NPF-10-278

ATTACHMENT "B"

UNIT 2 PROPOSED SPECIFICATION

**FIGURE 3.4-2**  
**SONGS 2 RCS HEATUP PRESSURE/TEMPERATURE**  
**LIMITATIONS FOR 4-10 EFY**

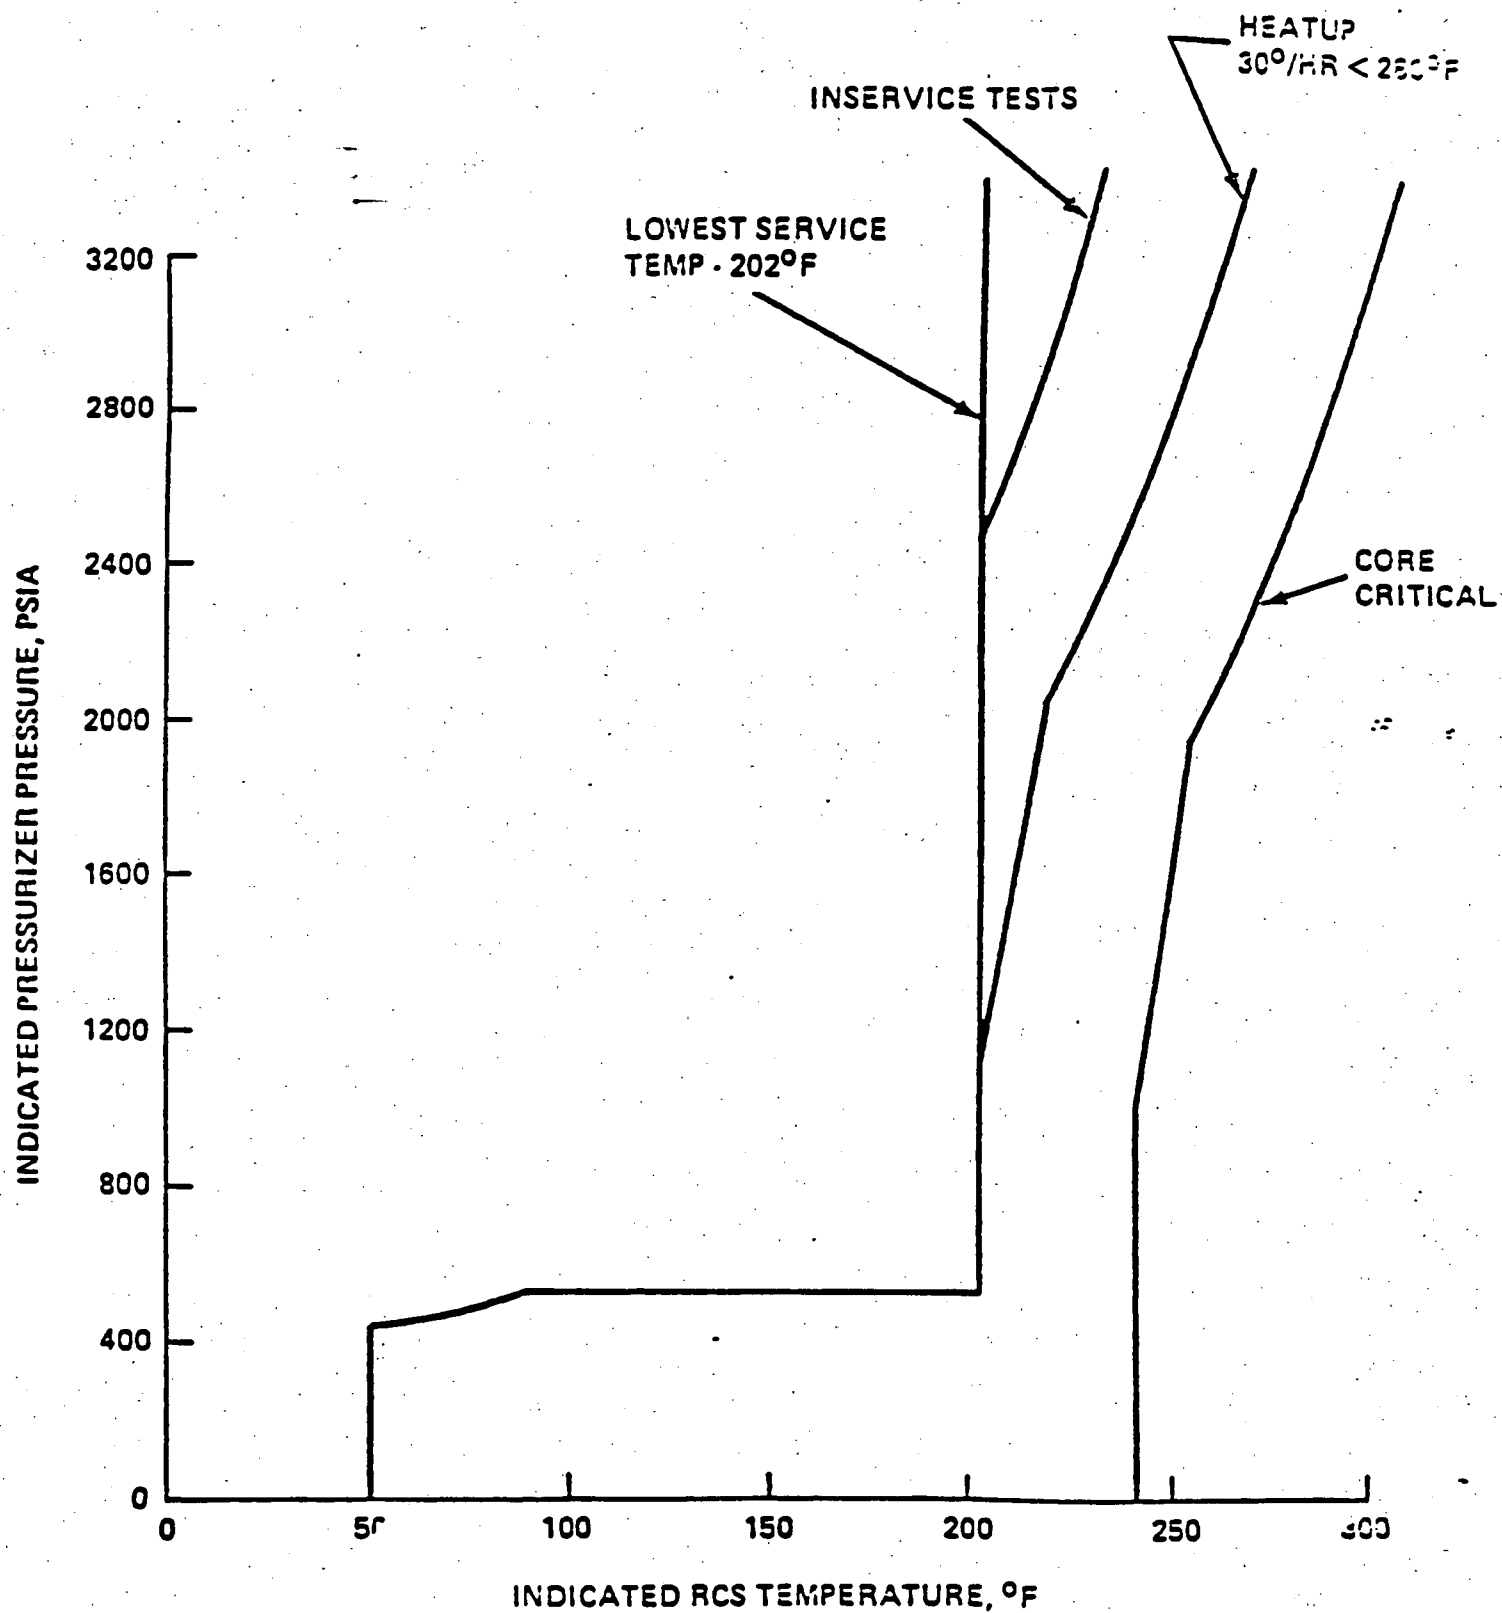
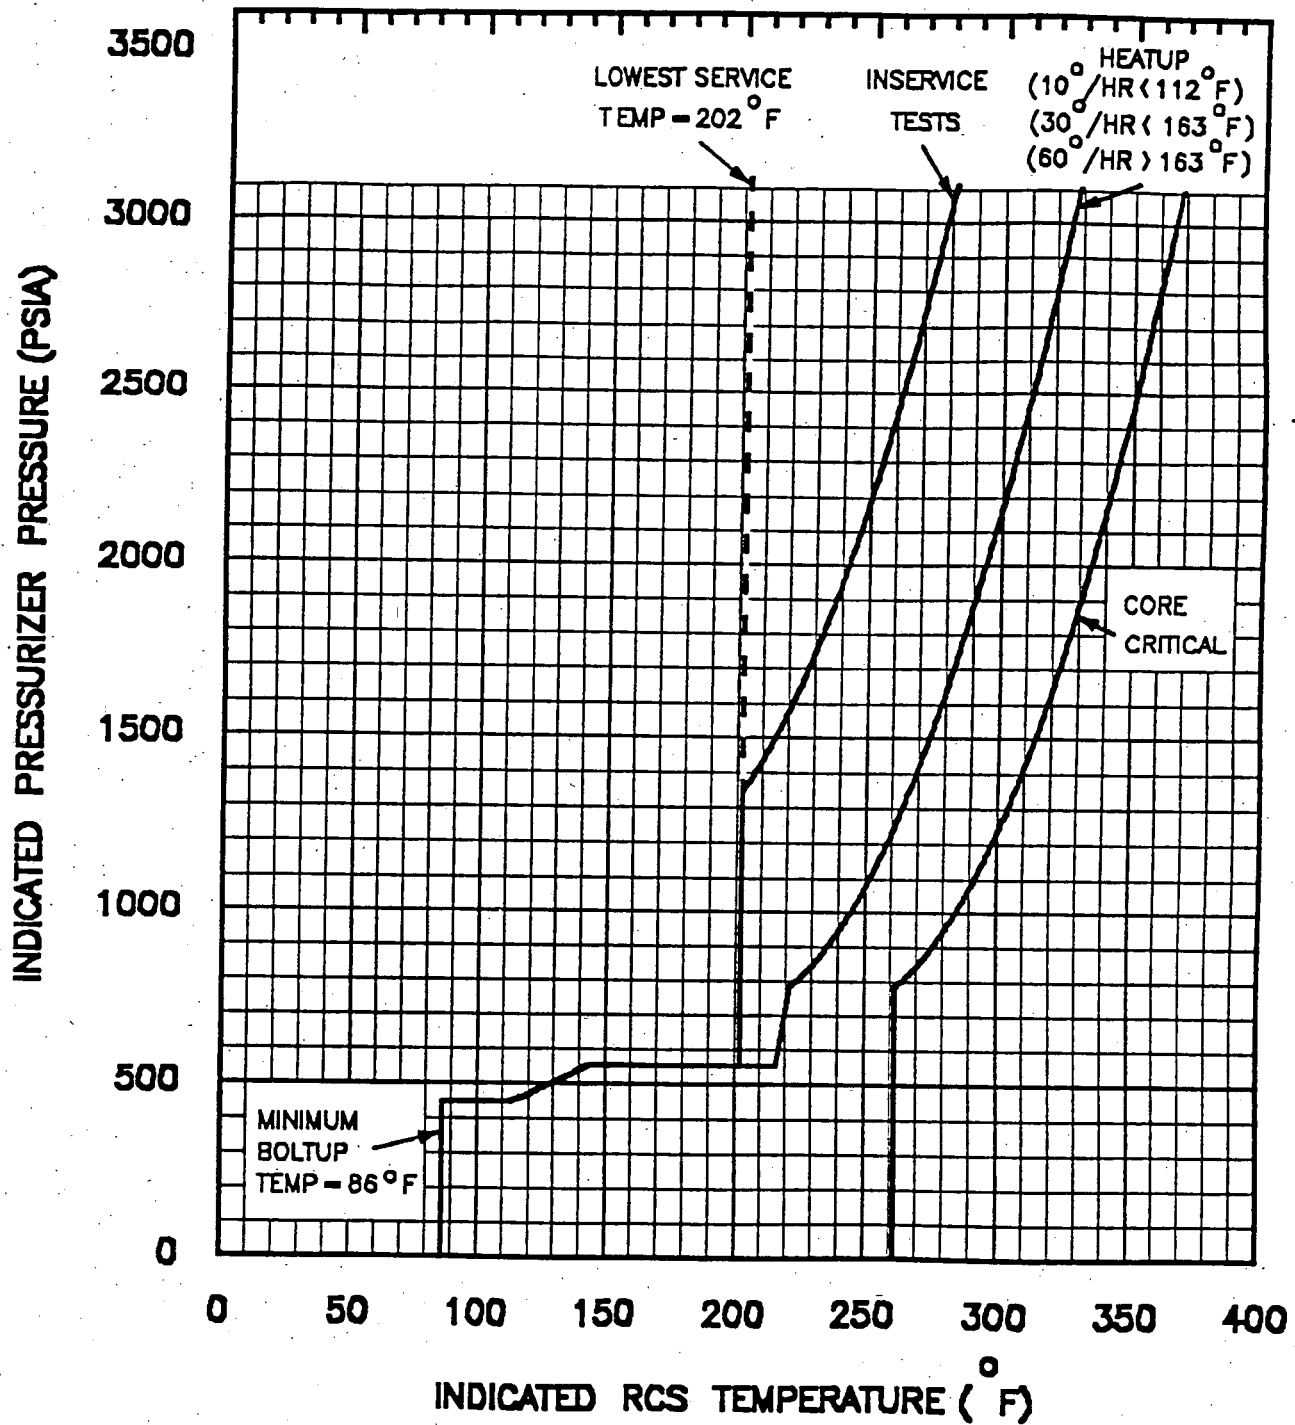
3.4.8.1 The Reactor Coolant System (except the pressurizer) temperature and pressure shall be limited in accordance with the limit lines shown on Figure 3.4-2 and Figure 3.4-3 during heatup, cooldown, criticality, and inservice leak and hydrostatic testing with:

- a. A maximum heatup of 30°F in any one hour period with RC cold leg temperature less than 280°F. A maximum heatup of 60°F in any one hour period with RC cold leg temperature greater than 280°F.
- b. A maximum cooldown of 30°F in any one hour period with RC cold leg temperatures less than 280°F. A maximum cooldown of 100°F in any one hour period with RC temperature greater than 280°F.
- c. A maximum temperature change of less than or equal to 10°F in any one hour period during inservice hydrostatic and leak testing operations above the heatup and cooldown limit curves.

3.4.8.1 The Reactor Coolant System (except the pressurizer) temperature and pressure shall be limited in accordance with the limit lines shown on Figure 3.4-2 and Figure 3.4-3 during heatup, cooldown, criticality, boltup, and inservice leak and hydrostatic testing with:

- a. A maximum heatup of 100°F in any one hour period with RC cold leg temperature less than 112°F. A maximum heatup of 30°F in any one hour period with RC cold leg temperature less than 163°F. A maximum heatup of 60°F in any one hour period with RC cold leg temperature greater than 163°F.
- b. A maximum cooldown of 100°F in any one hour period with RC cold leg temperature less than 103°F. A maximum cooldown of 30°F in any one hour period with RC cold leg temperatures less than 145°F. A maximum cooldown of 100°F in any one hour period with RC temperature greater than 145°F.
- c. A maximum temperature change of less than or equal to 100°F in any one hour period during inservice hydrostatic and leak testing operations above the heatup and cooldown limit curves.
- d. A minimum temperature of 86°F to tension reactor vessel head bolts.
